BIDS AND AWARDS COMMITTEE
Supplemental Bid Bulletin No. 35-2022

Supply, delivery, installation, configuration, and integration of Multi-Biometrics
Equipment to existing Payroll System of the BTr Regional and Provincial Offices
(ITB-13-2023-G EPA)

This Supplemental Bid Bulletin No. 35-2022 is issued to modify or amend items in the Bid Documents. This shall form an integral part of the Bid Documents.

Add item 5.1.1.2.6	5.1.1.2.6 Must have four (4) heavy duty swivel caster wheels with lock for easy transport.
Add item 5.1.1.2.7	5.1.1.2.7 Draft design of the pole and enclosure:

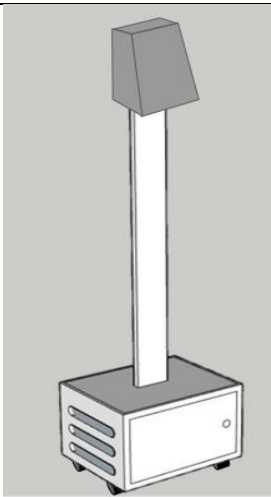
5.1.1.2 87 units of Pole stand to hold/support device, and with UPS cage/enclosure for easier transport; design to be approved by BTr.	
Add item 5.1.1.2.1	5.1.1.2.1 Height, tilt angle, and other specific details of the biometric setup shall be defined with respect to the proper orientation of the proposed biometrics device and UPS.
Add item 5.1.1.2.2	5.1.1.2.2 Biometrics must be attached to the pole in a secure/stable, ergonomic and enterprise-grade presentation.
Add item 5.1.1.2.3	5.1.1.2.3 Material to be used for the body can be made out of Galvanized Iron, equivalent or higher quality.
Add item 5.1.1.2.4	5.1.1.2.4 Design of the UPS Enclosure and pole should allow for easy maintenance of the UPS and connected peripherals.
Add item 5.1.1.2.5	5.1.1.2.5 The three sides of the Enclosure (Right, Left and back), must have louvers for ventilation purposes. The front side is the door and must have a lock.
